Report to the Future Melbourne (Planning) Committee

Agenda item 6.2

**Ministerial Planning Referral: TPMP-2019-29
132-136 Kavanagh Street, Melbourne****Presenter:** Evan Counsel, Director Planning and Building**1 December 2020****Purpose and background**

DELEGATE REPORT MINISTERIAL PLANNING REFERRAL

15. Base Floorplate and Adjusted Floorplate – DKO Architecture (Vic) Pty Ltd July 2020

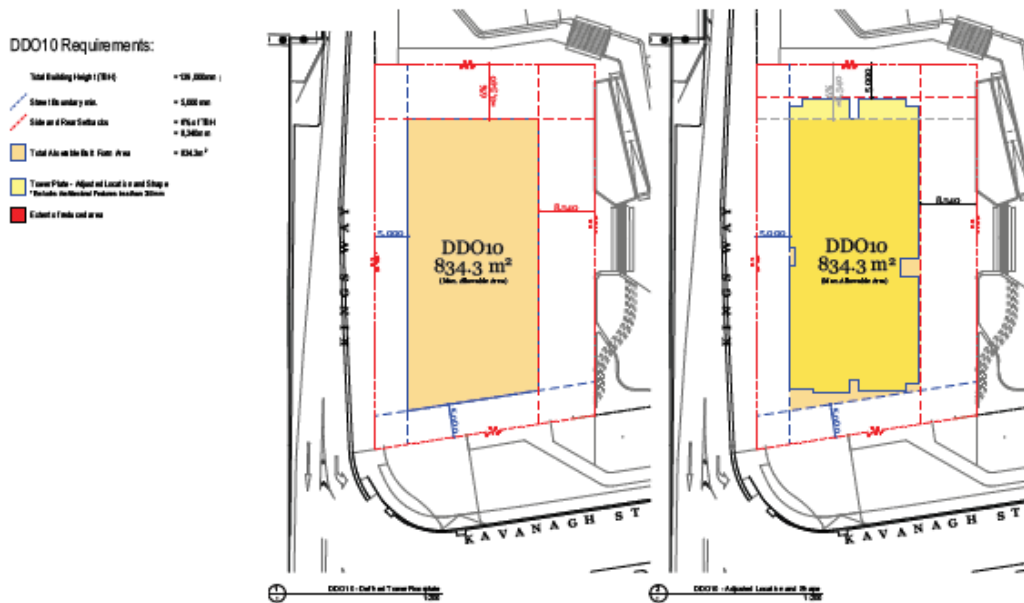
|Setback Compliance - DDO10
